VIBRATOR TESTING

Notes on the Checking and Adjustment of Vibrator Power Supply Systems

BY JOHN F. RIDER

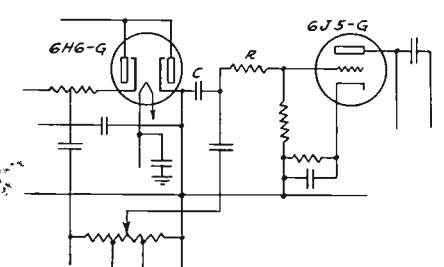
In some of these receivers distortion has developed when using the set at low volume. This has been found due to some r.f. getting through to the a-f system.

The correction is an r-f filter in the a-f grid circuit as shown in the accompanying schematic. This consists of a 150,000-ohm resistor and a 0.0005-mf condenser connected as shown.

C and R form the r-f filter. For values, see above

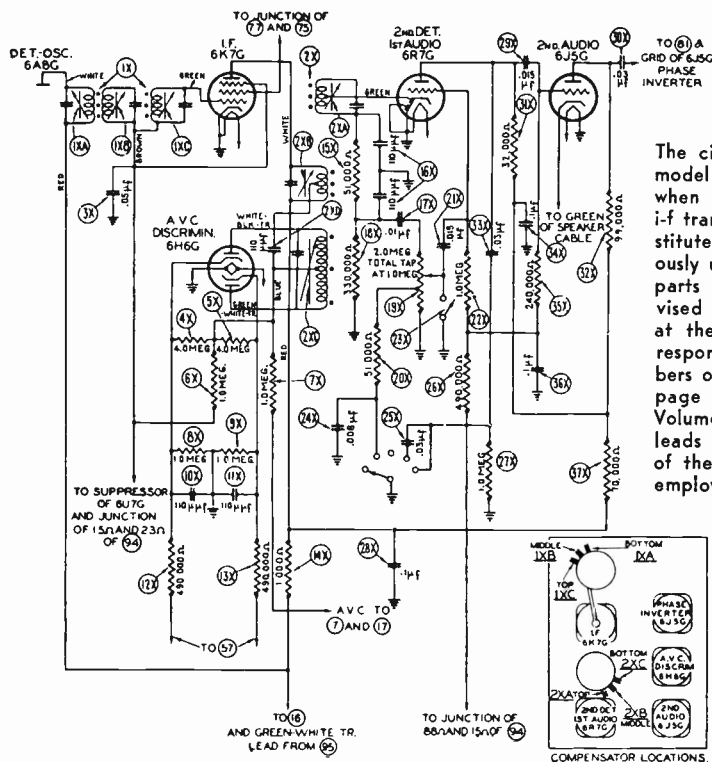
The circuit of the Philco model 38-2 was changed when permeability tuned i-f transformers were substituted for those previously used. Note that the parts numbers in the revised partial schematic at the left, do not correspond with the numbers on the schematic on page 8-55 of *Rider's Volume VIII*, but that the leads going to the parts of the circuit not shown, employ the original numbering.

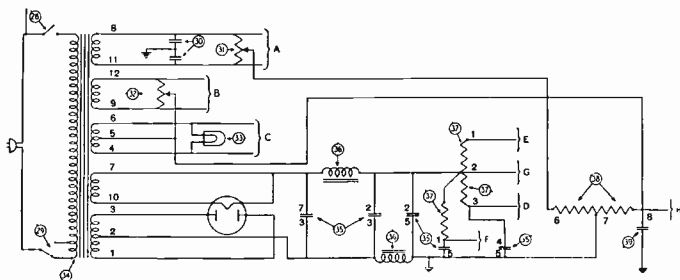
A change in the wiring has been made. The primary of the third r-f transformer instead of going to the left side of the resistor No. 17 now is connected to the other end. Plate voltage for the r-f tubes obtained from the point marked "D" in the voltage divider, No. 37, now is fed in to the resistors Nos. 7, 12, and 17 through

The accompanying partial schematic

Fig. 1 of the power pack and filter carries various numberings, which correspond to those of Figs. 2 and 3 and show the capacity values of the filter condenser packs No. 35 used for model 511 and 521 respectively. Note that the connections of the 1-mf condenser, 4-5, have been changed from the way they are shown in the schematic on page 8-107. Instead of terminal 4 of No. 35 being connected to terminal 3 of No. 37 it is connected to terminal 1 of No. 35.
